1.1 Definitions

Edwin I. Hatch Plant Units 1 and 2
GE Report NEDC-32405P
Power Uprate Safety Analysis Report

Figure 3.4.1-1 (Page 1 of 1)
Power-Flow Operating Map with One Reactor
Coolant System Recirculation Loop in Operation

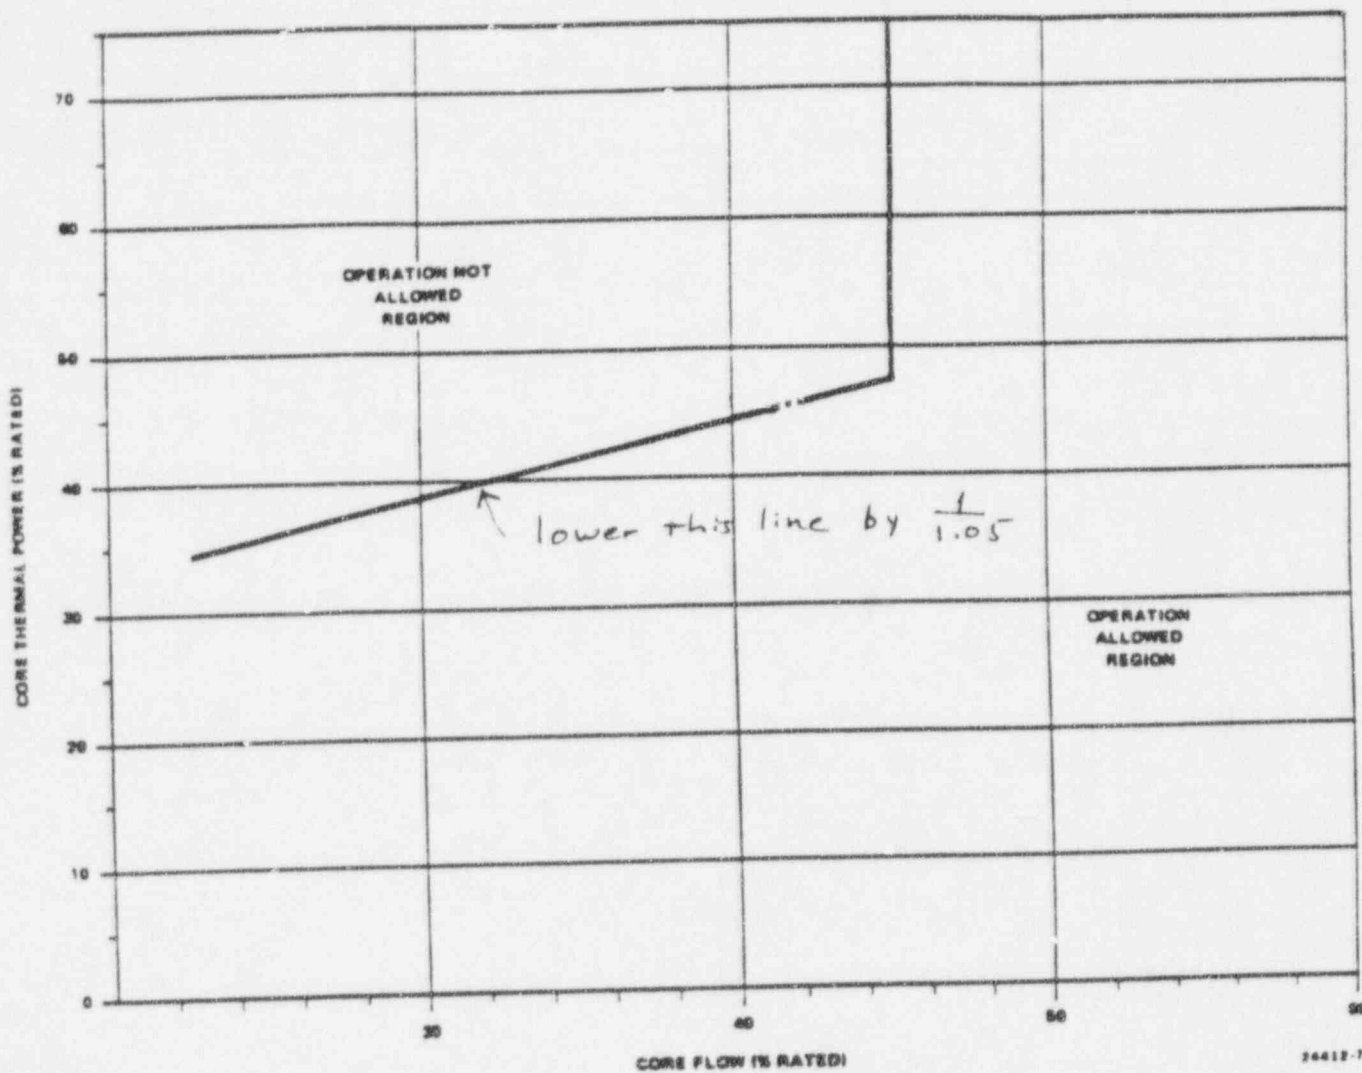
and APRM Flow Biased Simulated Thermal Power — High setpoint (LCO 3.3.1.1) must be applied to allow continued operation consistent with the assumptions of Reference 3. In addition, core flow as a function of core thermal power must be in the "Operation Allowed Region" of Figure 3.4.1-1 to ensure core thermal-hydraulic oscillations do not occur.

Due to thermal-hydraulic stability concerns, operation of the plant with one recirculation loop is controlled by restricting the core flow to $\geq 45\%$ of rated core flow when THERMAL POWER is greater than the ~~80%~~ rod line. This requirement is based on the recommendations contained in GE SIL-380, Revision 1 (Reference 4), which defines the region where the limit cycle oscillations are more likely to occur. If the core flow as a function of core thermal power is in the "Operation Not Allowed Region" of Figure 3.4.1-1, prompt action should be initiated to restore the flow-power combination to within the Operation Allowed Region. The 2 hour Completion Time is based on the low probability of an accident occurring during this time period, on a reasonable time to complete the Required Action, and on frequent core monitoring by operators allowing core oscillations to be quickly detected. An immediate reactor scram is also required with no recirculation pumps in operation, since all forced circulation has been lost and the probability of thermal-hydraulic oscillations is greater.

Figure 3.4.1-1 (Page 1 of 1)
Power-Flow Operating Map with One Reactor
Coolant System Recirculation Loop in Operation

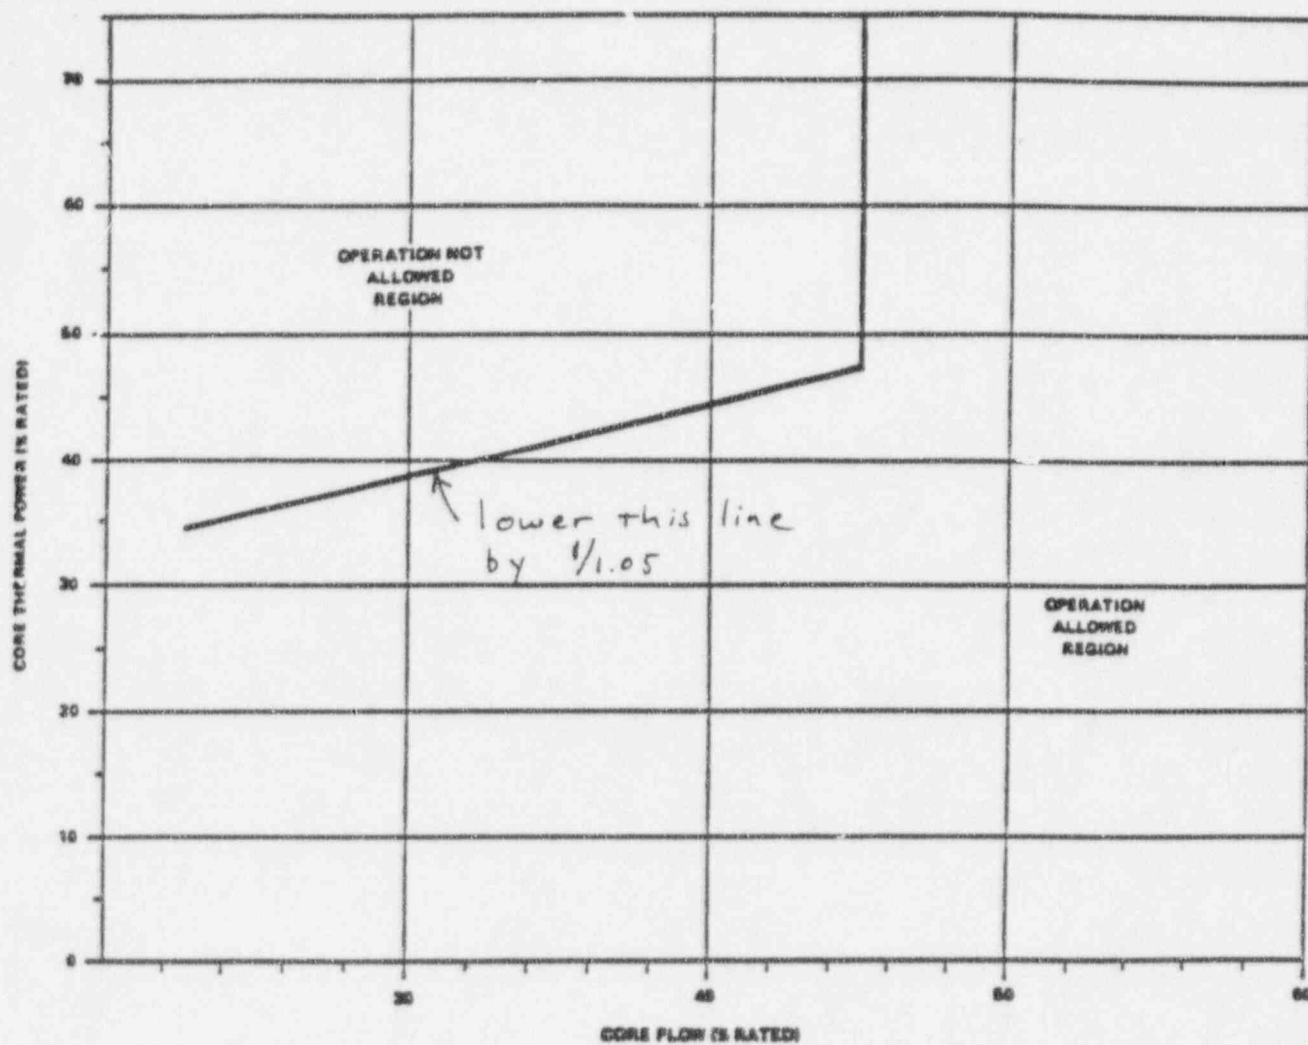
and APRM Flow Biased Simulated Thermal Power — High setpoint (LCO 3.3.1.1) must be applied to allow continued operation consistent with the assumptions of Reference 3. In addition, core flow as a function of core thermal power must be in the "Operation Allowed Region" of Figure 3.4.1-1 to ensure core thermal-hydraulic oscillations do not occur.

Due to thermal-hydraulic stability concerns, operation of the plant with one recirculation loop is controlled by restricting the core flow to $\geq 45\%$ of rated core flow when THERMAL POWER is greater than the 80% rod line. This requirement is based on the recommendations contained in GE SIL-380, Revision 1 (Reference 4), which defines the region where the limit cycle oscillations are more likely to occur. If the core flow as a function of core thermal power is in the "Operation Not Allowed Region" of Figure 3.4.1-1, prompt action should be initiated to restore the flow-power combination to within the Operation Allowed Region. The 2 hour Completion Time is based on the low probability of an accident occurring during this time period, on a reasonable time to complete the Required Action, and on frequent core monitoring by operators allowing core oscillations to be quickly detected. An immediate reactor scram is also required with no recirculation pumps in operation, since all forced circulation has been lost and the probability of thermal-hydraulic oscillations is greater.
